**GOLD PARK HOMES**

PROJECT/LOCATION MCLAUGHLIN AND MAYFIELD BRAMPTON, ON

SITE PLAN

PROJECT No 13098 LOT NUMBER 5

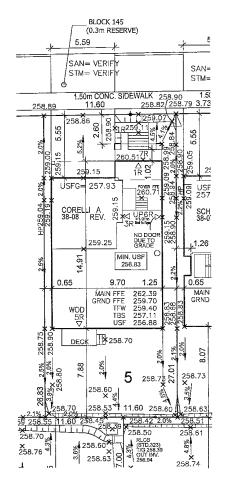
1) No final utility location information at this time, Urbantech will not be responsible for future changes to design. Builder should notify purchaser's that street hardware and above ground utility furniture may be added or removed from their frontages.

Builder to lower underside of footings where adjacent to RLCB leads.
Exact depth to be determined on site during footing excavation.

3) Builder to stake out driveway curb depressions at time of curb installation

4) Builder to verify location of all hydrants, street lights, transformers and all other services. If min. dimensions are not maintained as per City standards, builder is to relocate at his own expense.

6) Final fence design have not been provided at this time. Purchaser to be advised that actual fencing details may not be as shown on this plan.
